Submission with respect to Moorebank Intermodal Precinct West Stage 3 SSD-10431)

From: Sharyn Cullis. PhD, Science and Technology Studies UNSW, Secretary Georges River Environmental Alliance. M. 0421 714 391.

DPIE Draft Conditions of Consent and recommended Amendments.

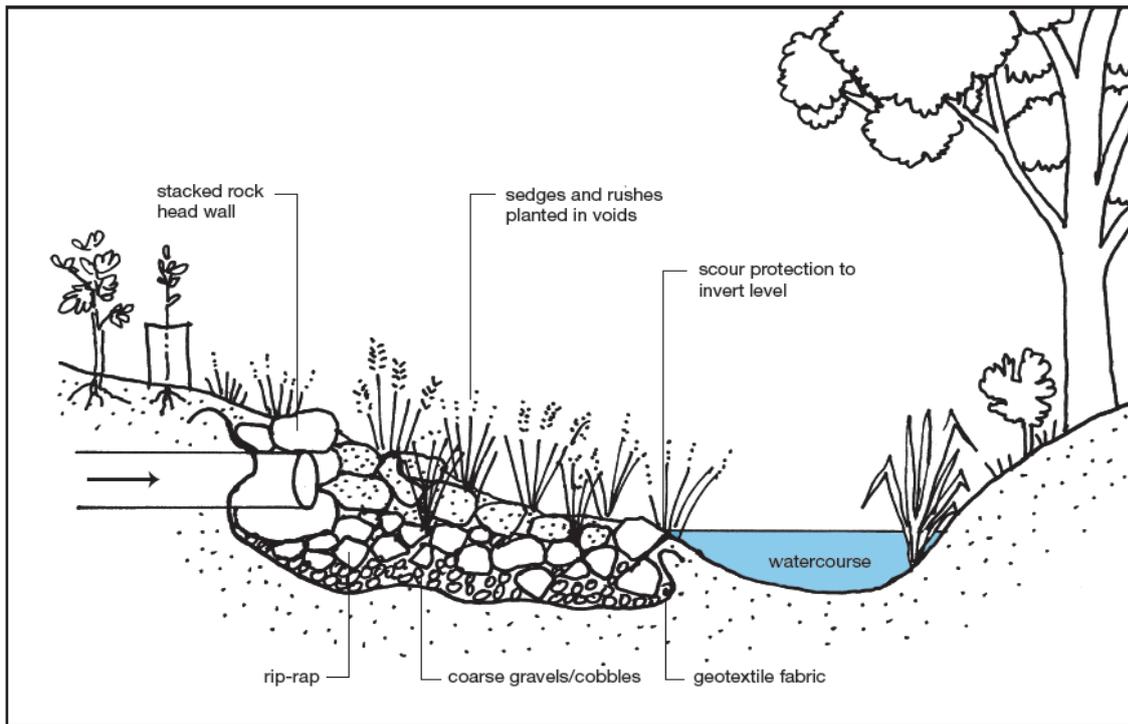
**Finally in respect to Stormwater
Stormwater
Stormwater Management Plan approved Stage 2**

No slippage ...bioretention

Explicitly provide for the bioretention, which requires space...a deep single OSD doesn't do it....where are the filtering reedbeds...you can't cut into the EEC, so where on the pavement you are about to approve for Stage 3

Hydrocarbon stripping and stormwater harvesting etc p 37.
